ADDENDUM No. 5

Project:Washtenaw - AdditionLocation:7400 South Huron River Dr., Ypsilanti, MI, 48197Contract No:Y21456File No:511/21326.CAKDMVA No:26C8022016A/E File #:2105-01Date:August 24th, 2022

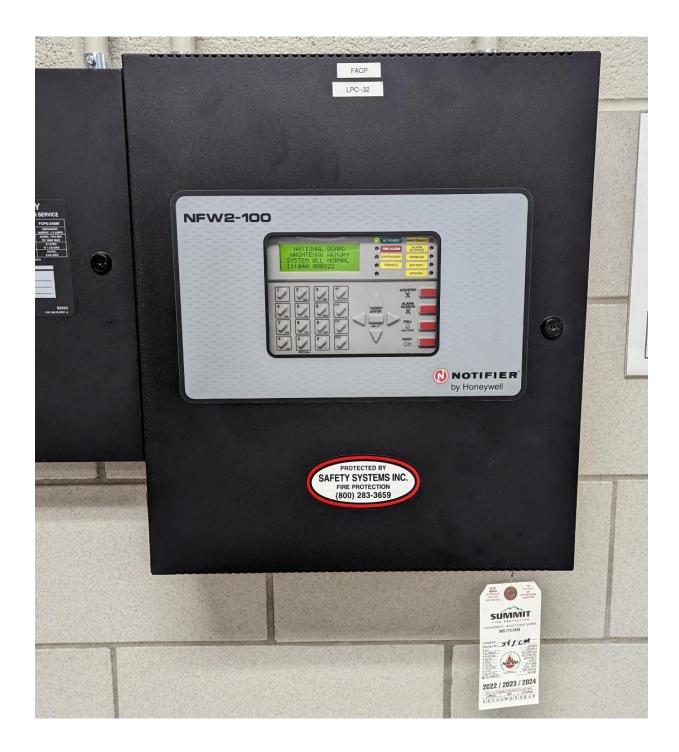
- I. Questions and Answers from the Bidding Period:
 - Question 1: The specs state that this project will extend the buildings existing Fire Alarm System - Notifier by Honeywell. Verify. If the extension is of the Notifier panel, then that should be the only equipment listed. Is this a new fire system that is open to the other manufacture equipment?
 - Answer 1: Modify Specification section 28 31 00-2.1 to remove listed alternate manufacturers. New notifier panel and associated components shall match the existing panel. See Below for photos of existing panel.
